PRODUCT ADVISORY

Data Sheet Specification Correction for the Listed Intersil ISL4260* QFN Packaged Products

**Refer to:
PA10066**

Subject: **Data Sheet Specification Correction for the Listed Intersil ISL4260*
QFN Packaged Products**

Incorrect POD – PA10066

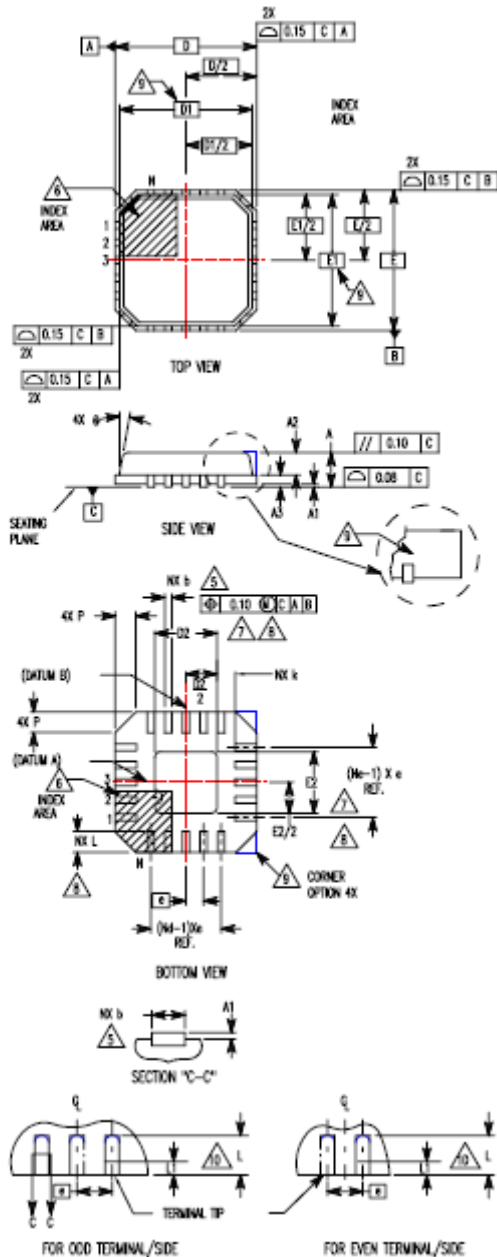
This advisory is to inform you that Intersil has made corrections to the POD (Package Outline Drawing) referenced in the data sheet specification for the listed Intersil ISL4260* QFN (Quad Flat No-Lead) packaged products. The updates to the POD correct the exposed pad dimensions and incorporate Intersil's new POD format. There have been no changes made to the package or product itself. The updated data sheet incorporating the corrected POD is available on the Intersil web site at <http://www.intersil.com/data/fn/fn6035.pdf>.
